# TECHNICAL BULLETIN

TB 004

**Subject: Membrane Shimming**

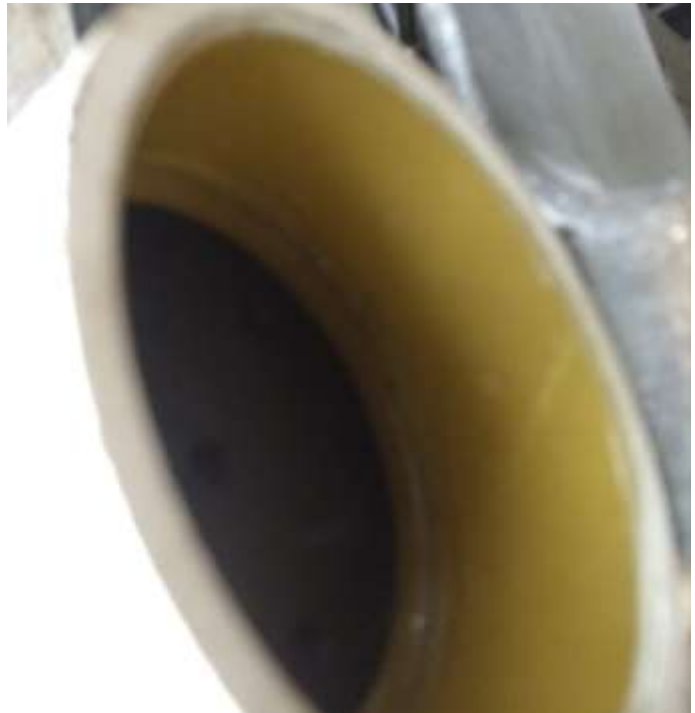
This technical bulletin explains how to install a spacer. If the length of the permeate tube is shorter than specified, the distributor or technician can cut a 1" PVC inner diameter pipe and add it to each membrane vessels assembly on the feed port.

See attached photos for shimming a Parker single element 6" SWRO vessel.

This vessel and membrane required two shims for tight installation.
